ADDENDUM NUMBER 4

- 1.01 DATE: MAY 17, 2021**
- 1.02 PROJECT: RENOVATIONS TO BUCHANAN HALL PHASE II**
- 1.03 PROJECT NUMBER: DCM NO. 2021305**
- 1.04 OWNER: ALABAMA A&M UNIVERSITY**
- 1.05 ARCHITECT: NOLA | VAN PEURSEM ARCHITECTS, PC**

SHEET NUMBER
M-2.4
OF
19

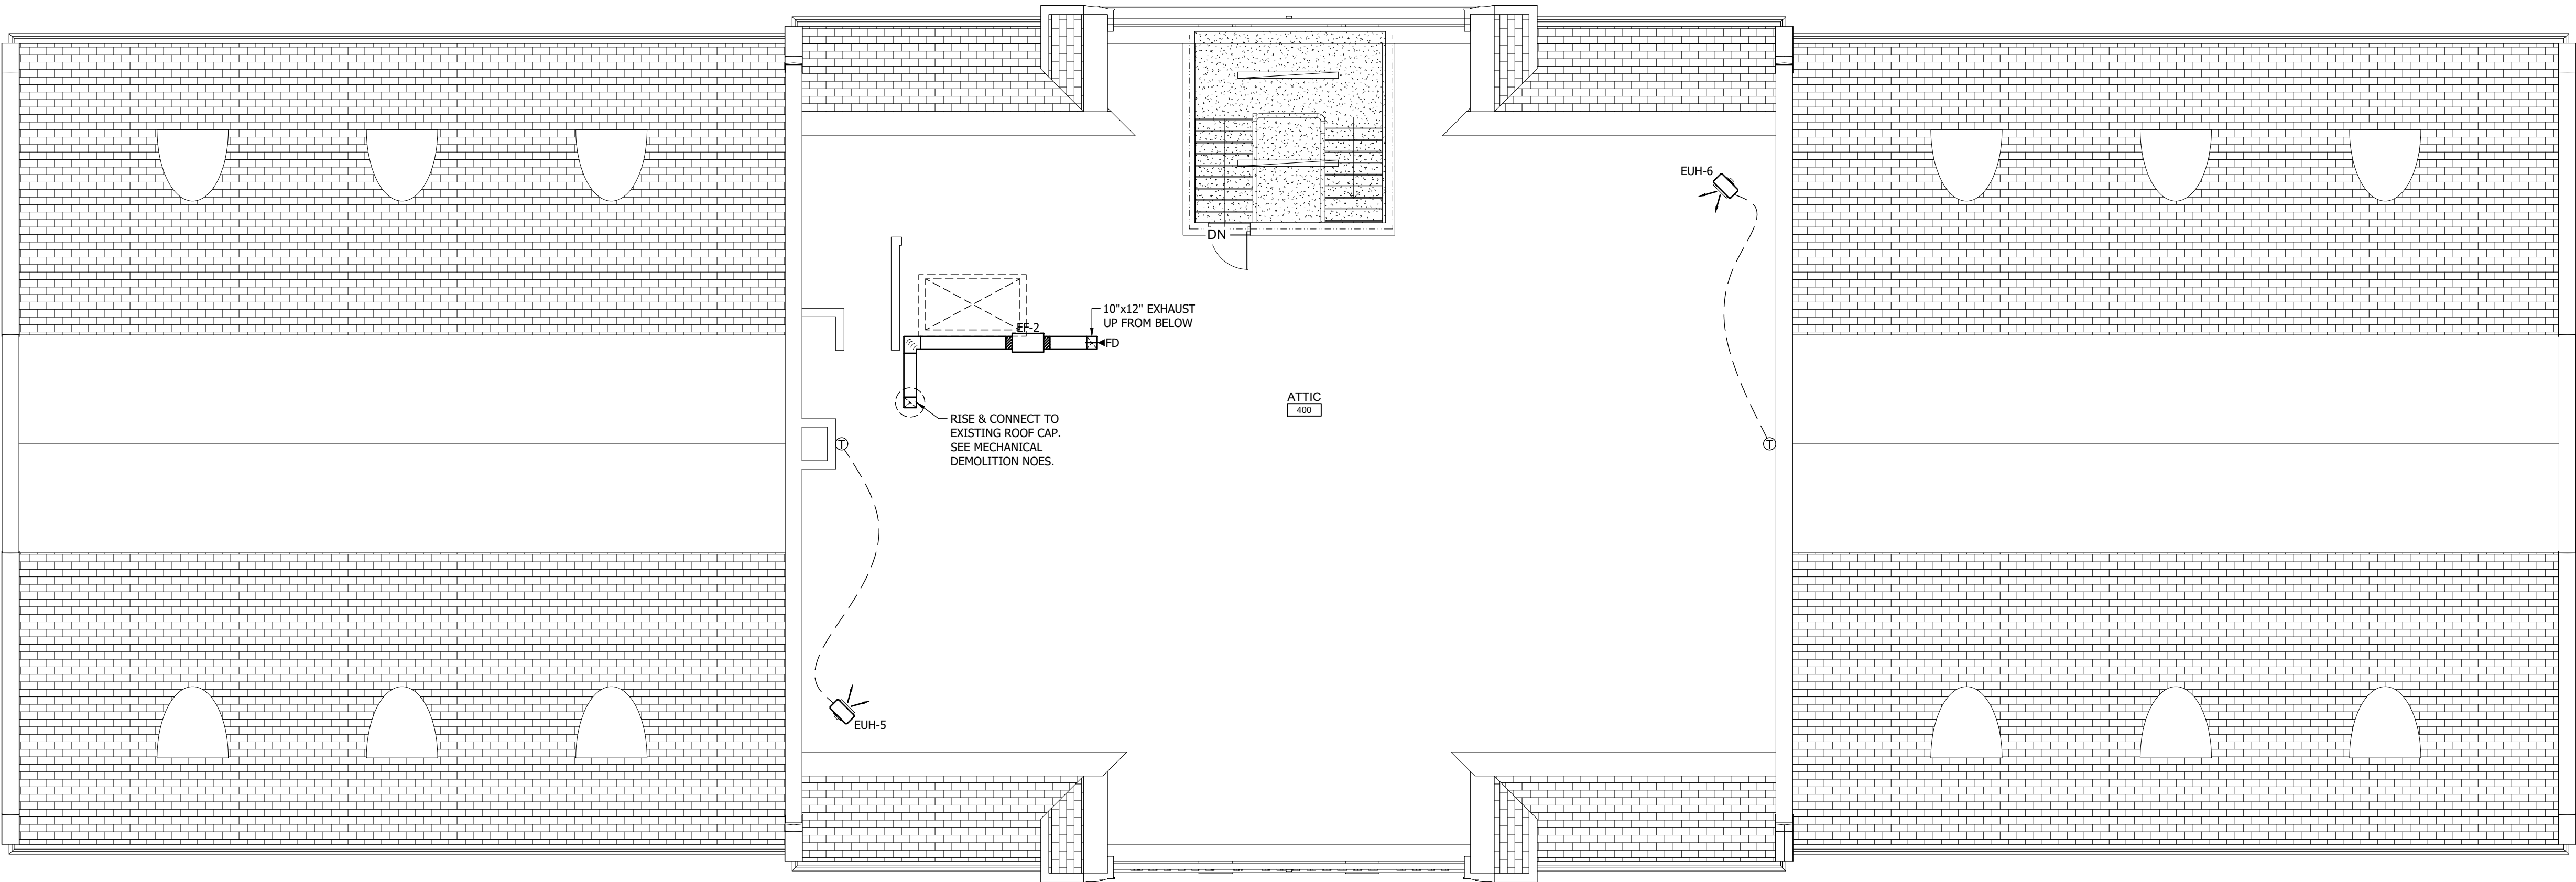
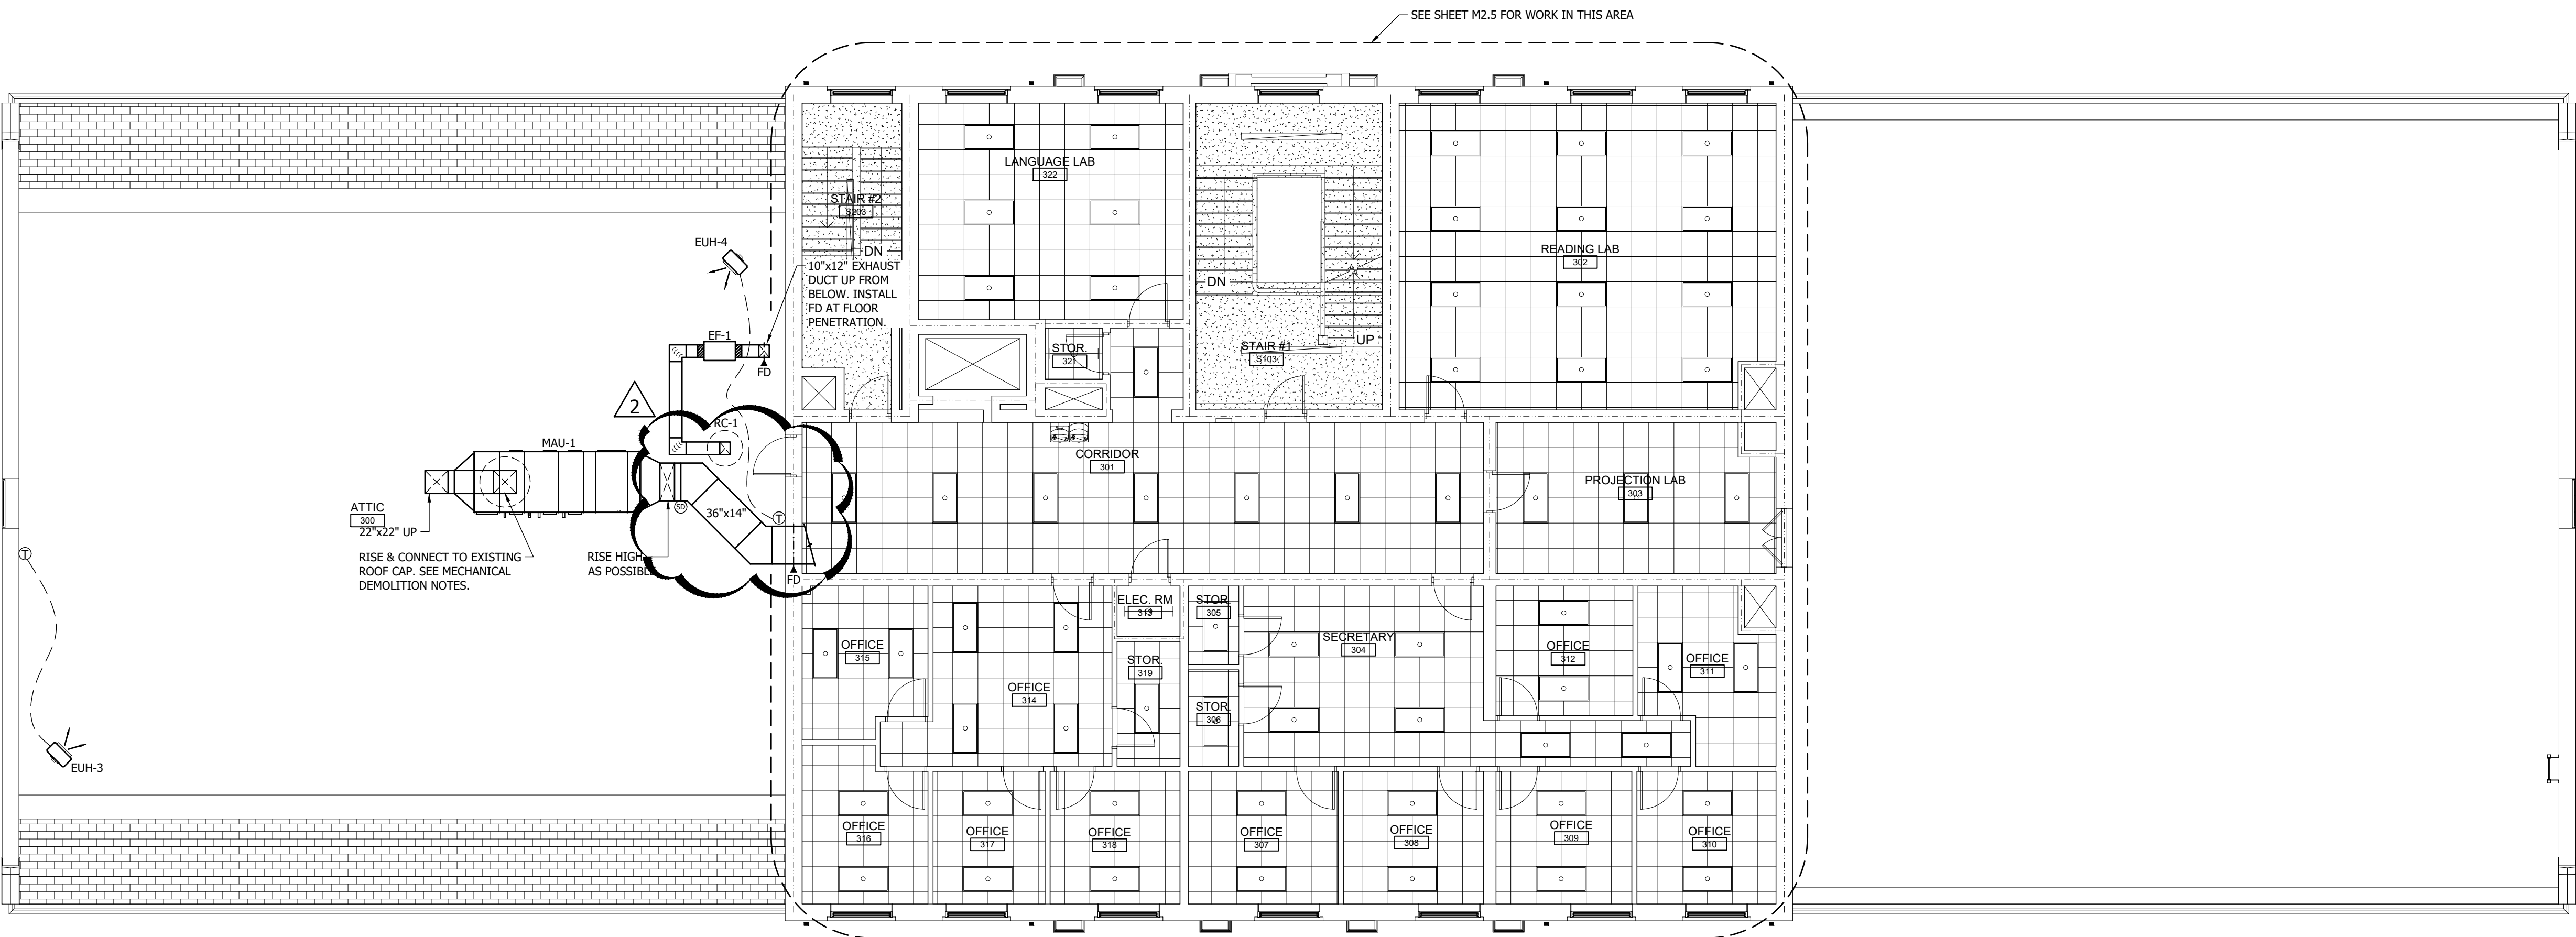
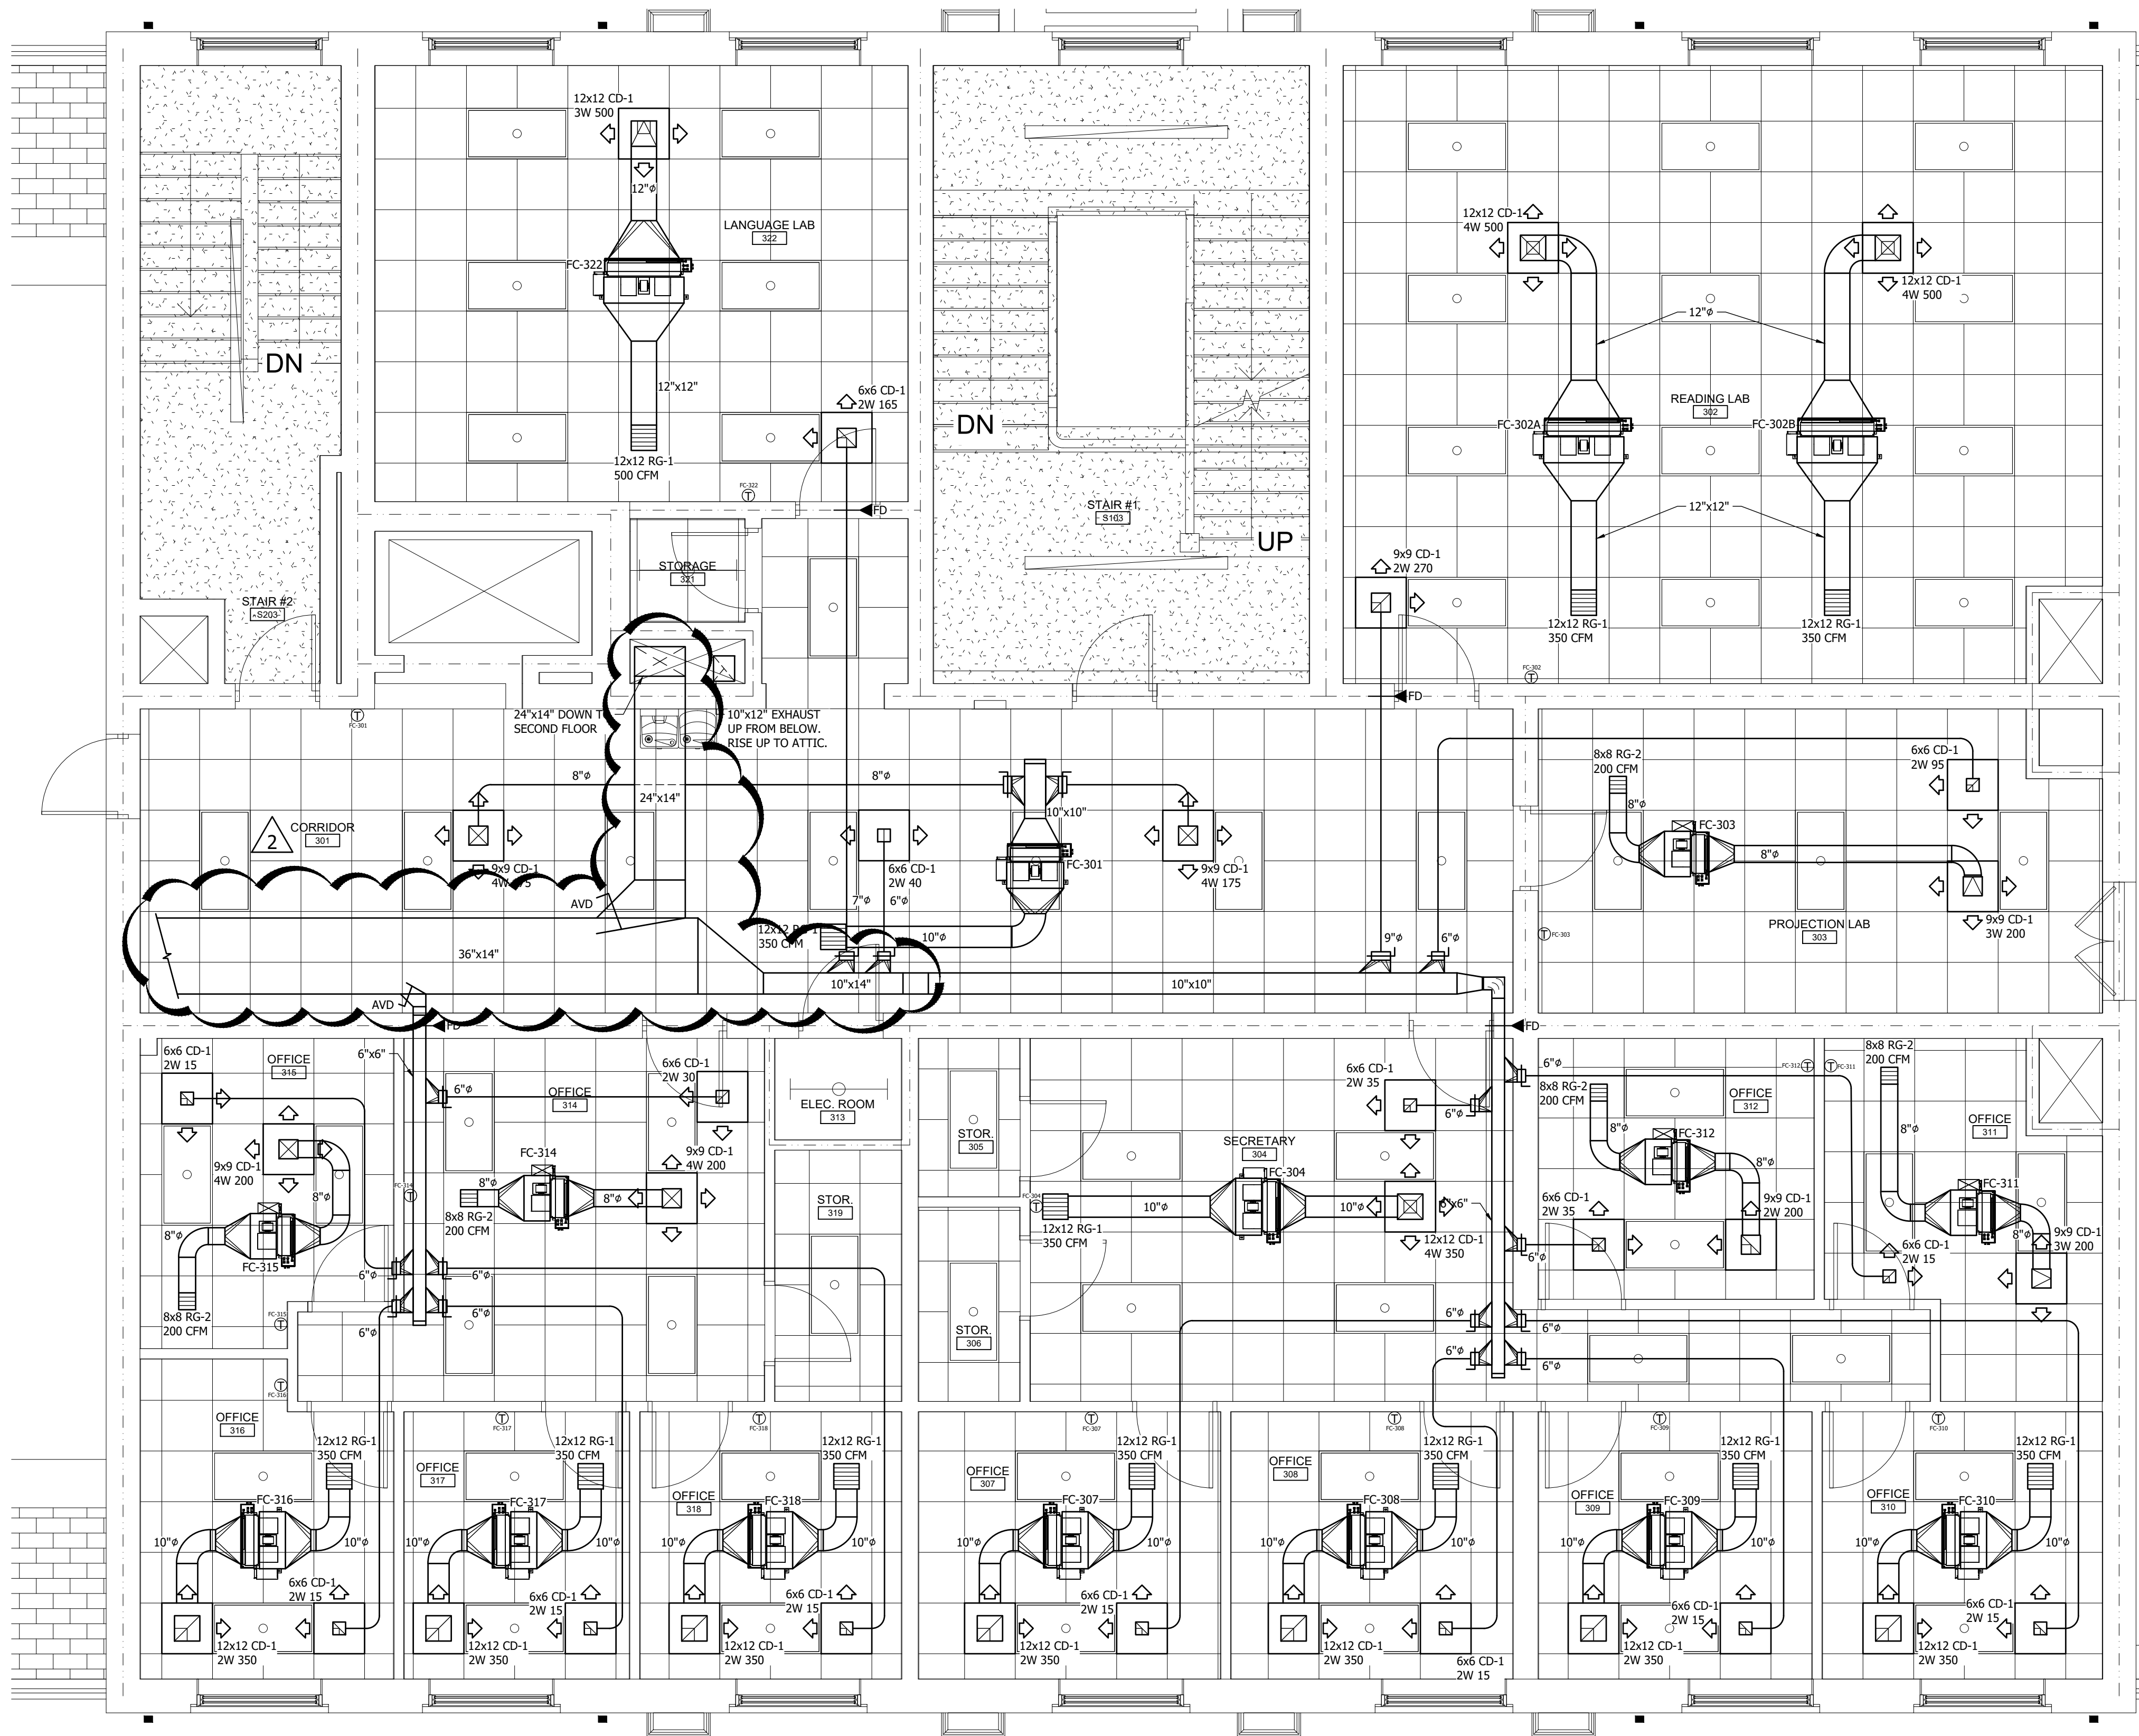
4.04 SHEETS M-2.1, M-2.3, M-2.4, & M-2.5:

- A. Replace these sheets in their entirety. Revisions include:
 - 1. Re-routing new ductwork to better access existing floor openings.
